MUNICIPAL CORPORATION,
KARACHI

ORDER UNDER SCH. VI, CHP. XI, RULE 5 (1) OF
ACT XVII OF 1933.

PLAN SHOWING PROPOSED BUILDING
ON PLOT NO 14 SHEET NO M.M.5. MUCHHI
MIANI QUARTER KARACHI. SCALE 8"=1"

Re: Proposed Building on plot No.14,
MM-5, Machi Meani Quarter.

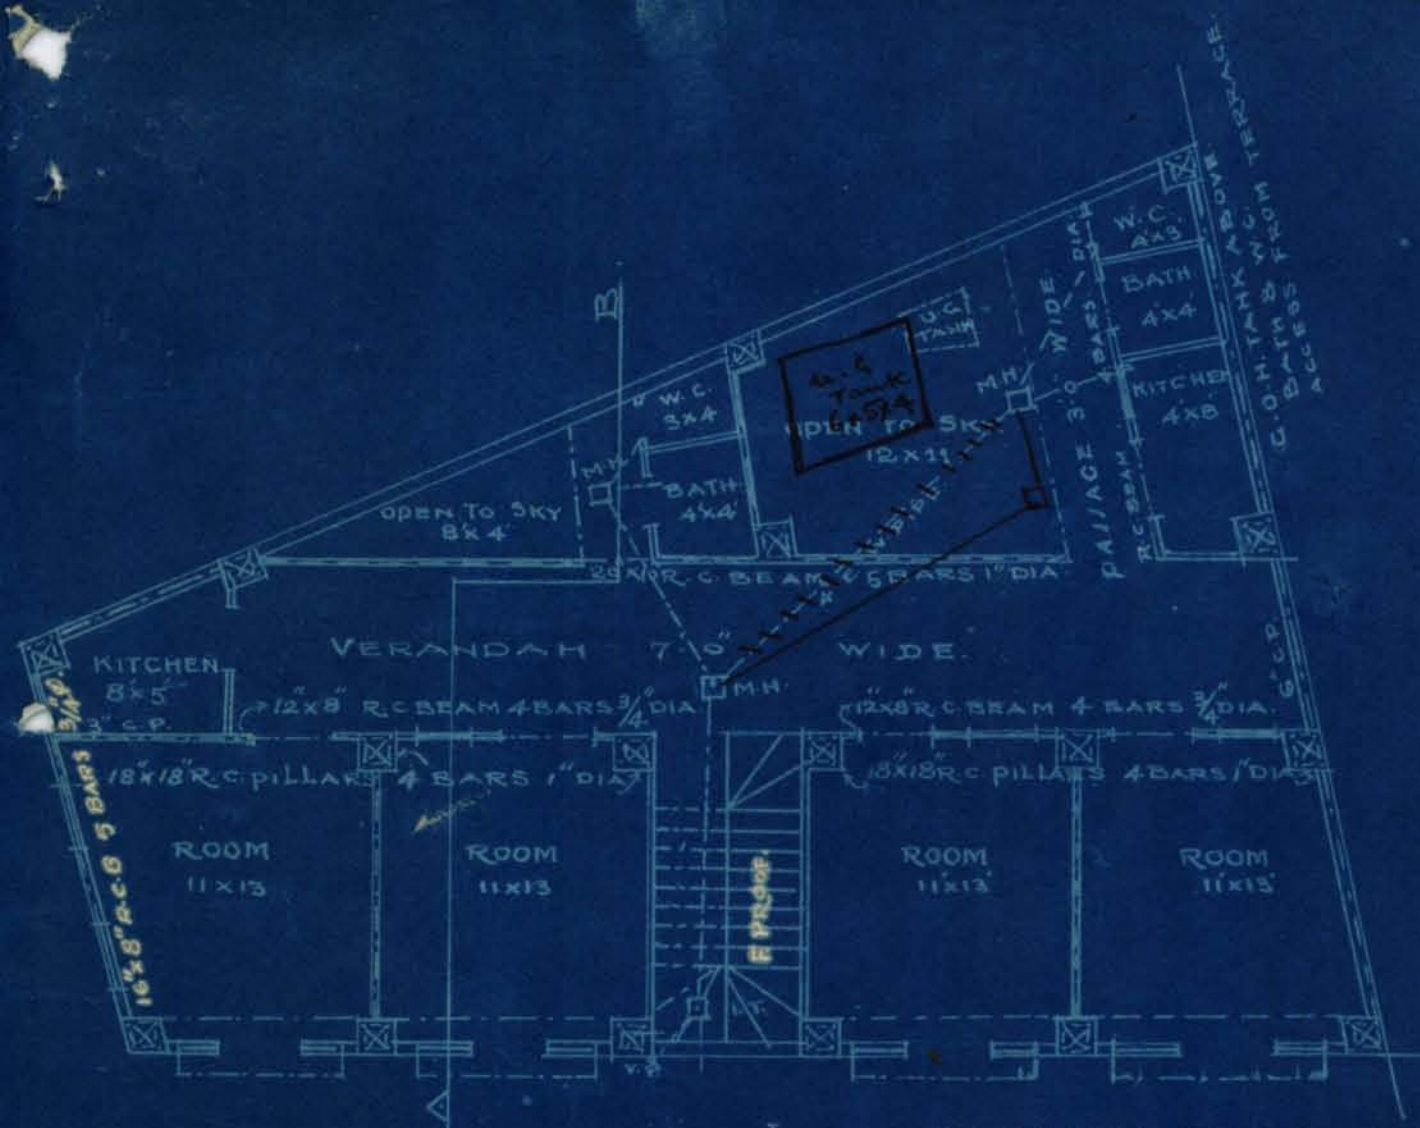
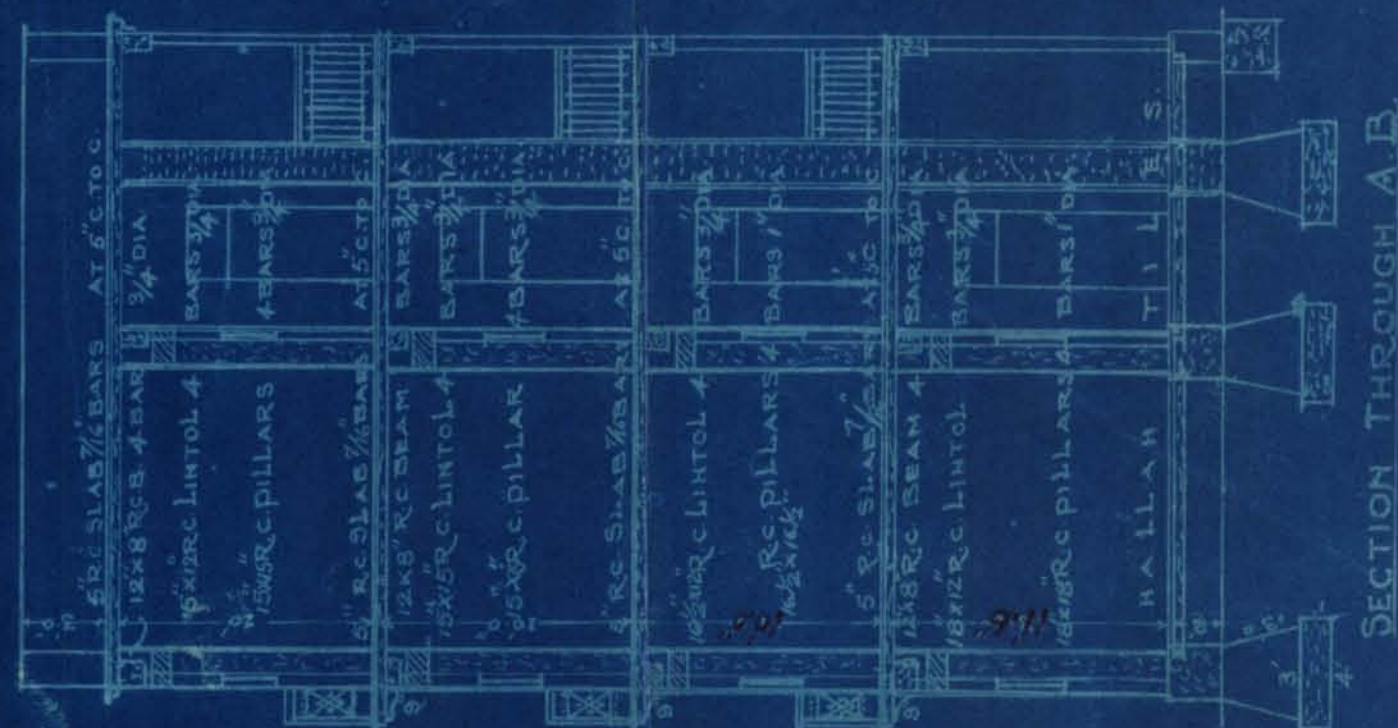
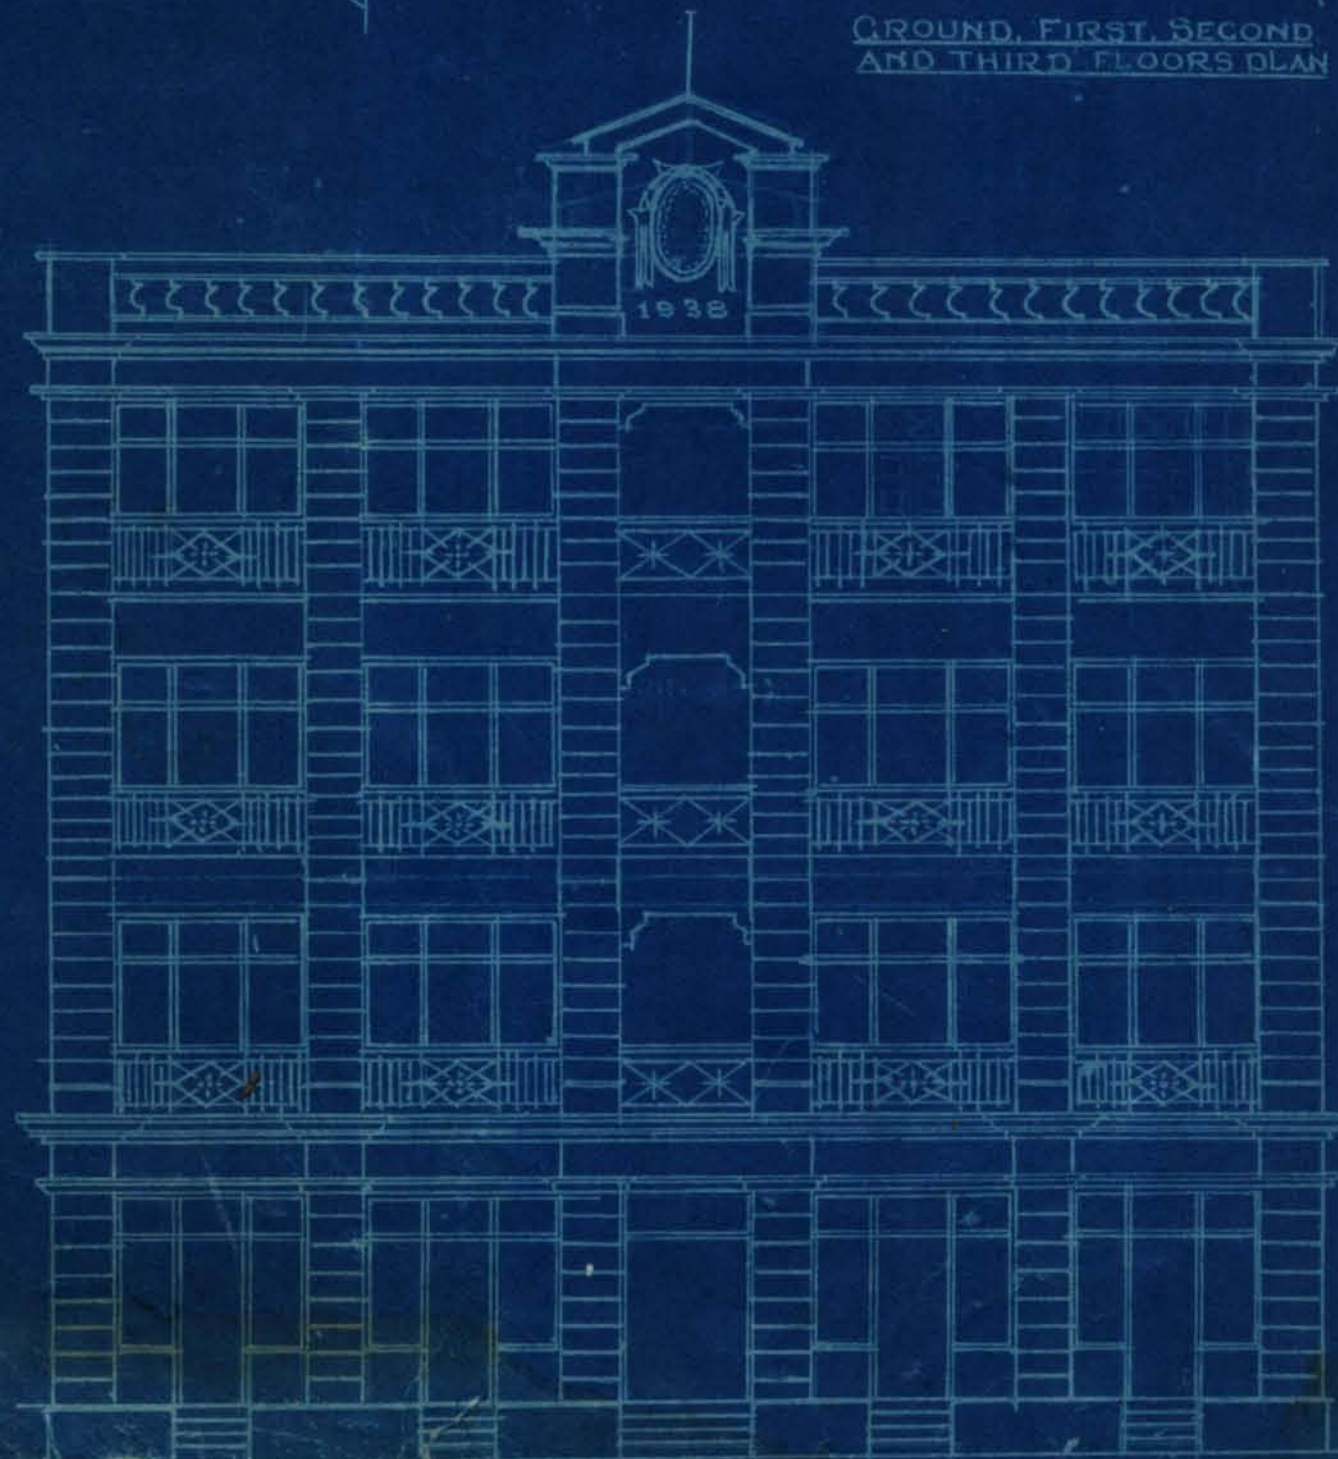
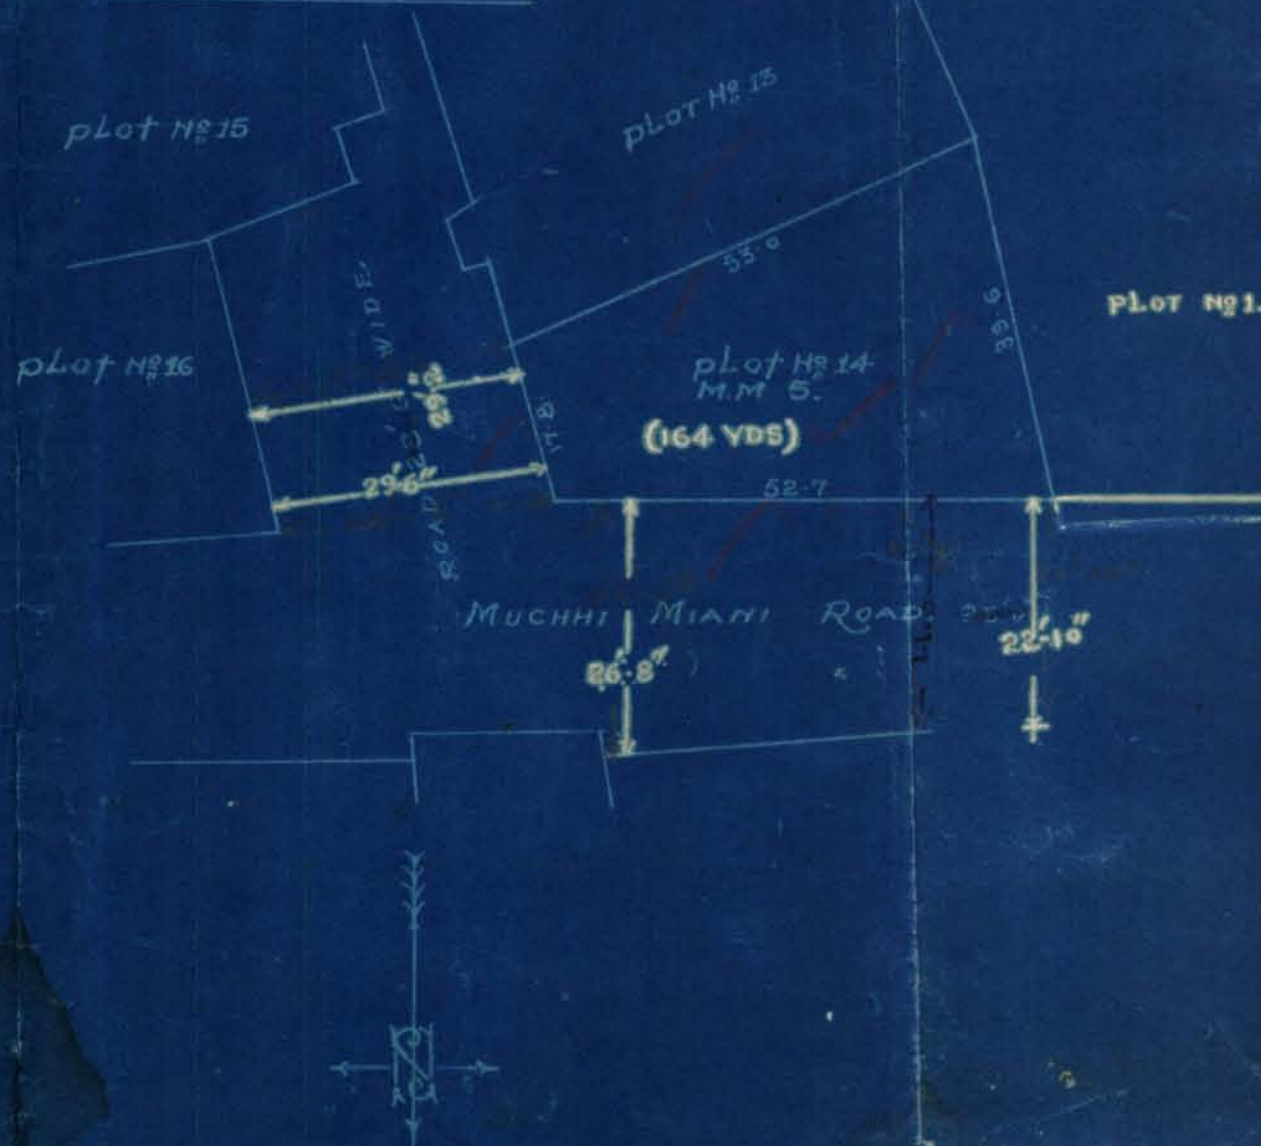
*I Adjoining plot no. 1 has shown
 II App. height with L & B
 measure at width. vide 2/5*

1. Adjoining plot No.1 to be shown.
2. Appointment be kept with Land Sureveyor to measure ^{street} ~~ext~~ width.

3. The fourth floor beyond 40 ft. depth from the Street on East is not permissible under the rules.
4. Size of beam "A" be given.

5. Street width be jointly checked with L.S and height regulated according
6. Calculations for R.C.C. be submitted

1. Street width be jointly checked with D.S. and height regulated accordingly.

2. Size of beam 'A' be given

1. The fourth floor beyond 40 ft. depth from the St. on East ~~Qr~~ is not permissible under the rules

2. Size of beam 'A' be given

*L.S.
 objection as 1 has
 been complied with
 please see ans. 2
 27/6/38*

*No objection to the plans as
 corrected. The height being 43' 6"
 as per corrections made.*

1. As desired, adjoining plot No.1 has been duly shown.
2. The Street widths have been properly shown. The same may however be again checked by the Land Surveyor, if so desired.

3. Only ground and three floors are proposed to be built on the above plot, the total height of which ^{including plinth} will be only 45 ft. There is no fourth floor as stated in your letter. The Street on the East is over 29 ft. wide, whereas the minimum width of Machi Meani Road No.2 in front of the above plot is 22'-10". In accordance with the municipal rules the building could therefore be carried to a height of atleast 46 ft., whereas, as already stated, the height of the proposed building will be only 45 ft.

4. Size of beam "A" has been duly given, as desired.
5. As desired, the street widths will again be jointly checked with the Land Surveyor and the height regulated accordingly.

6. The sizes of the R.C.C. beams and reinforcement etc. is as per P.W.D. Handbook.

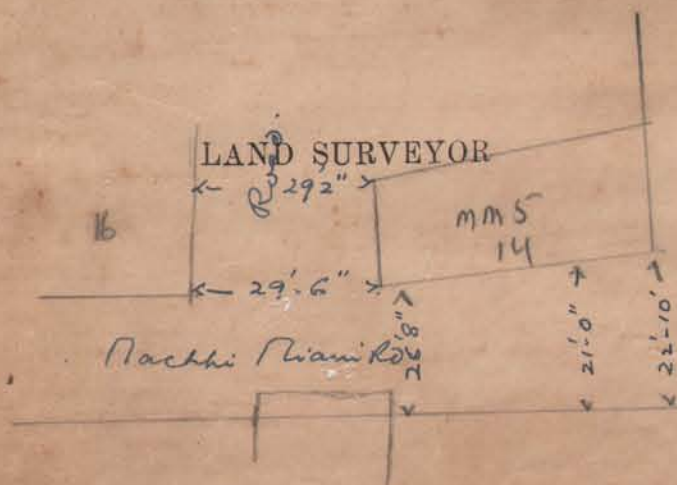
(1) Adjoining plot - ans. 1, to be shown

(2) width of Muchhi Miami Road to be shown as correct

(2) Apppt. be kept with L.S. to measure st. width.
